**STAFF REPORT**  
**KETCHUM PLANNING AND ZONING COMMISSION**  
**MEETING OF MAY 19, 2020**

- PROJECT:** Mountain Land Design Showroom & Residences Design Review
- FILE NUMBER:** P20-027
- APPLICATION TYPE:** Design Review
- APPLICANT:** Michael Doty Associates Architects
- PROPERTY OWNER:** Dan Devenport (360 Views LLC per Blaine County Assessor's Office)
- LOCATION:** 111 N Washington Avenue (Ketchum Townsite: Block 39: Lot 4)
- ZONING DISTRICT:** Mixed-Use Subdistrict of the Community Core (CC-2)
- NOTICE:** A public hearing notice for the project was mailed to all owners of property within 300 feet of the project site on April 29<sup>th</sup>, 2020.
- REVIEWER:** Abby Rivin, Associate Planner

C1.0

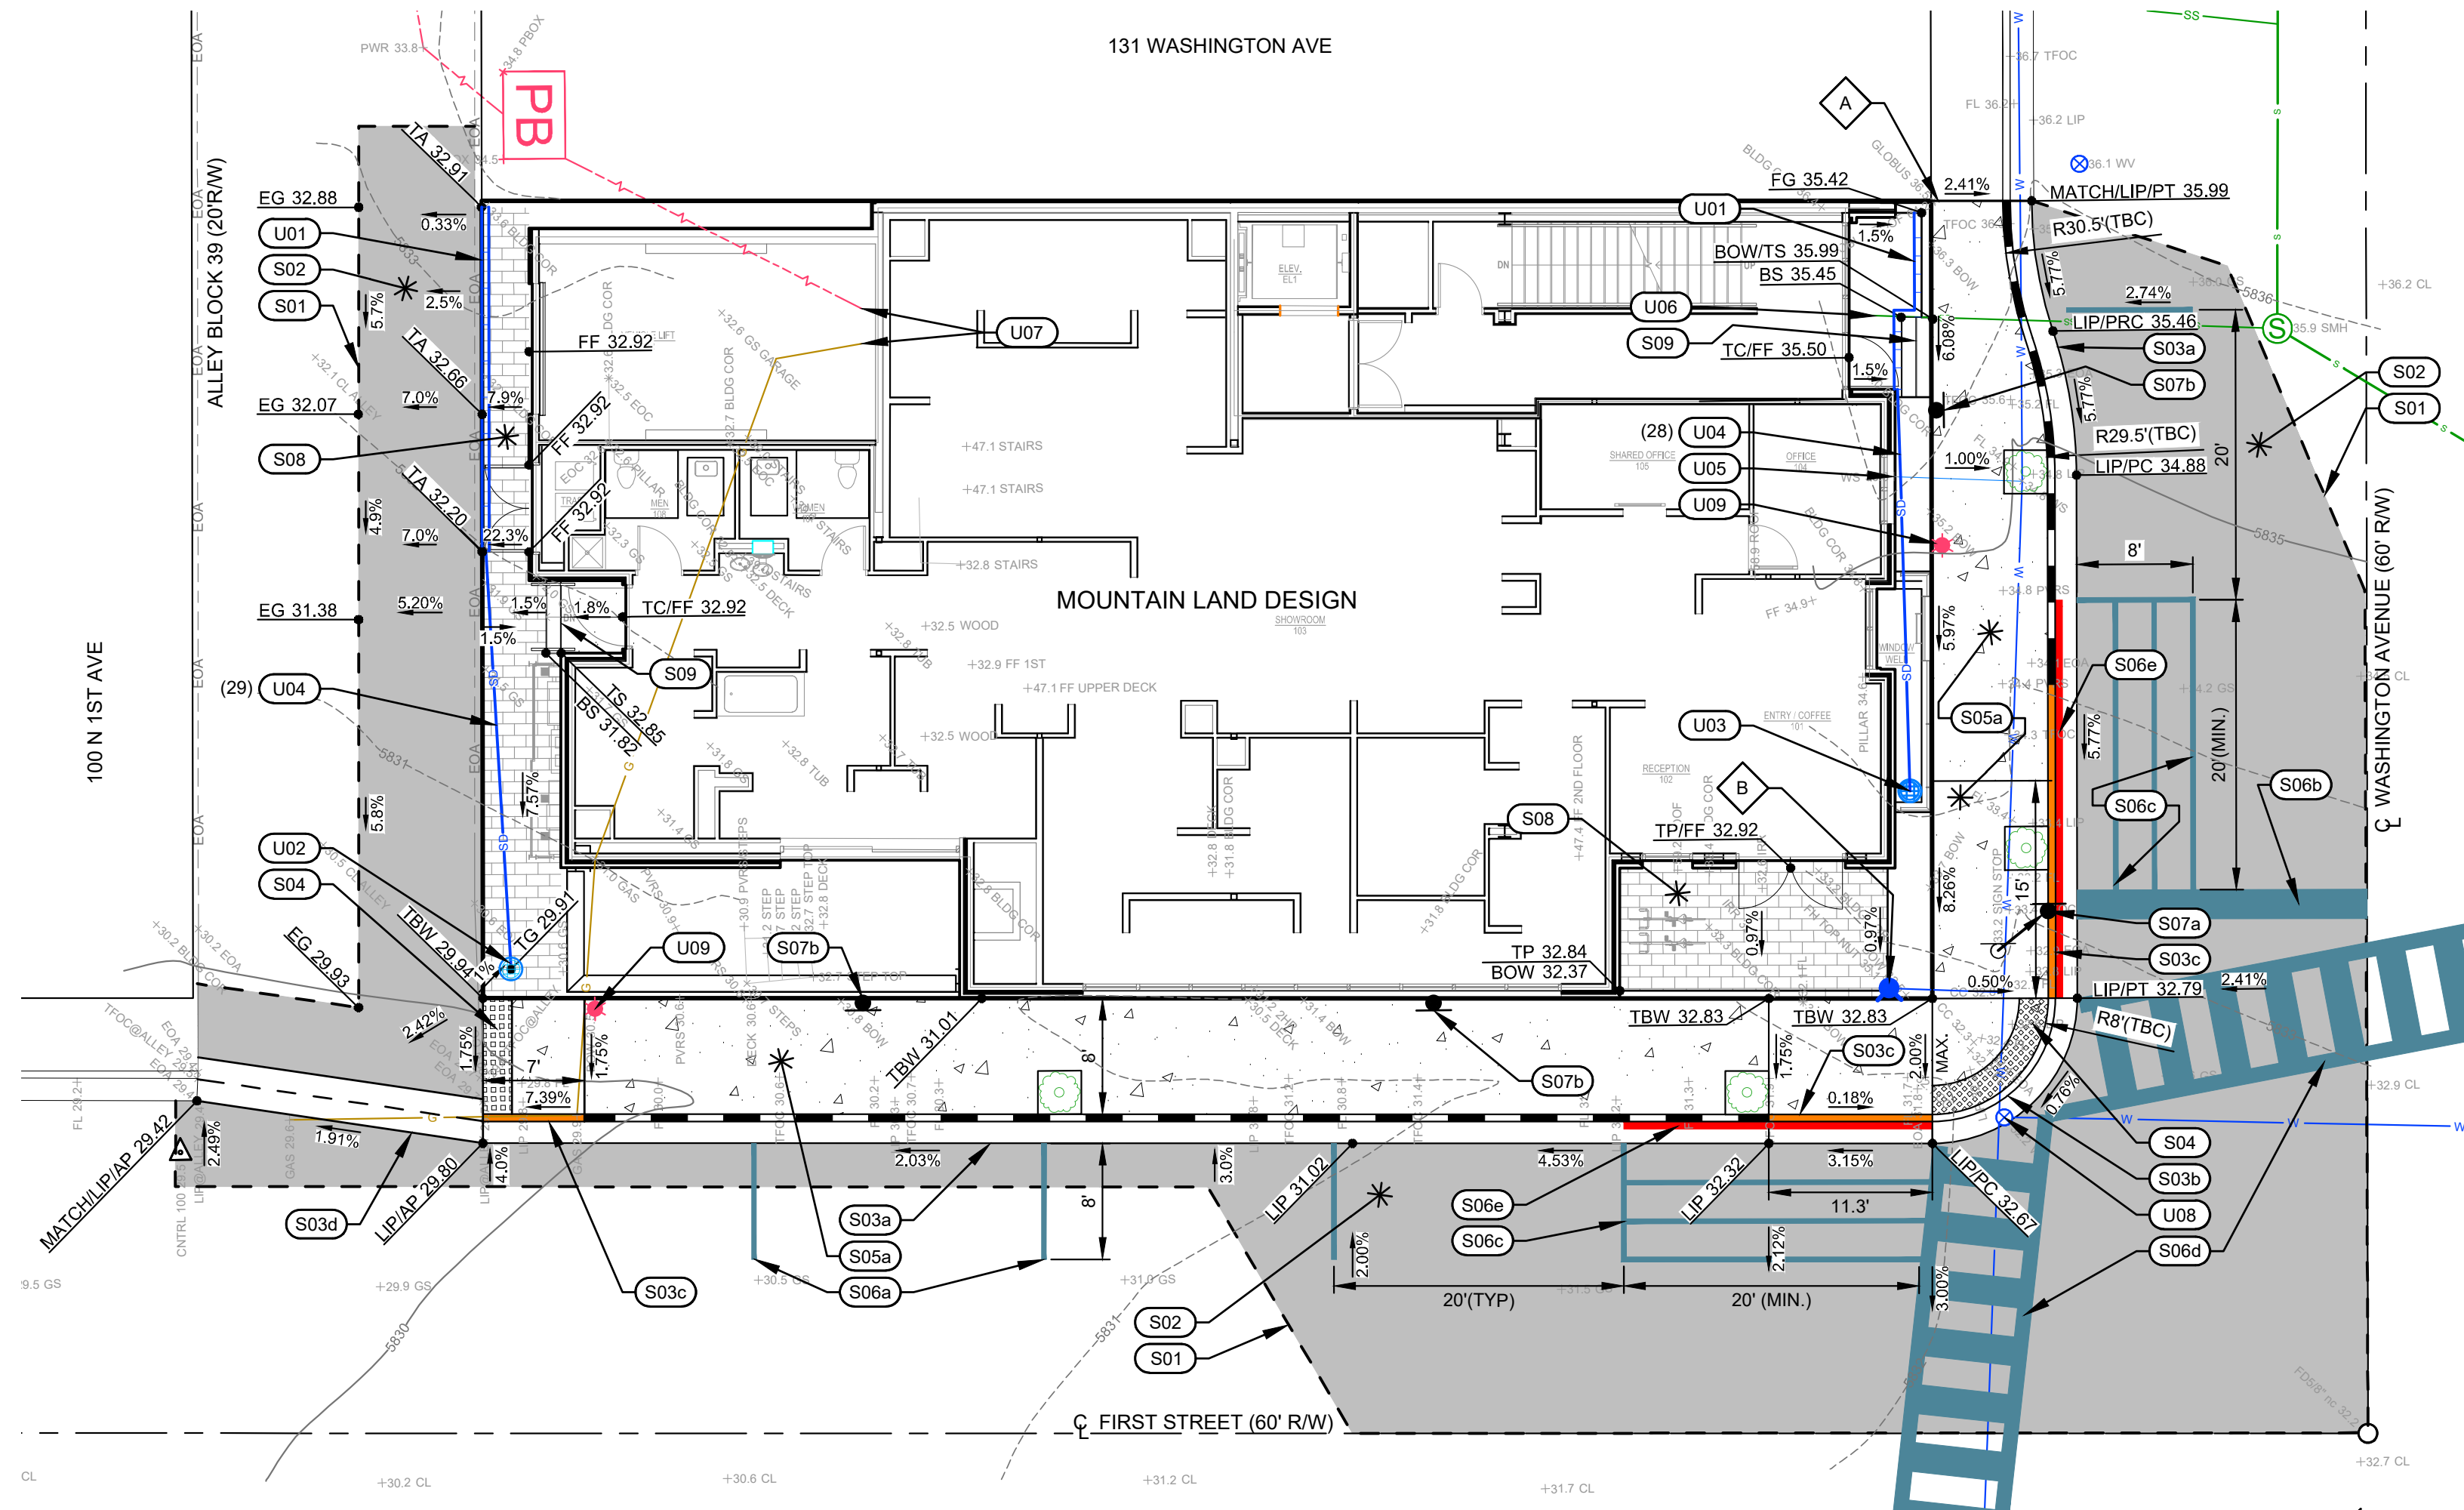
<i>Staff Comments</i>	<p>All storm water is proposed to be retained on site, including storm water from roof drains. Sheets C1.0 and C2.0 indicate the proposed drainage improvements.</p> <p>Roof drain locations and specifications must be indicated the project plans submitted with the Building Permit application for review and approval by the City Engineer.</p> <p>Prior to issuance of a Building Permit for the project, the applicant shall submit a final drainage plan indicating grading, catch basins, piping, and drywells (KMC §17.96.040.C.2b &amp; KMC §17.96.060.C.1-4) prepared by a civil engineer licensed in the state for review and approval by the City Engineer and Streets Department. See Table 1 for City Department comments including City Engineer and Streets Department conditions.</p>
<input checked="" type="checkbox"/>	<input type="checkbox"/>	<input type="checkbox"/>	17.96.060.C2 Drainage	<p>Drainage improvements constructed shall be equal to the length of the subject property lines adjacent to any public street or private street.</p>
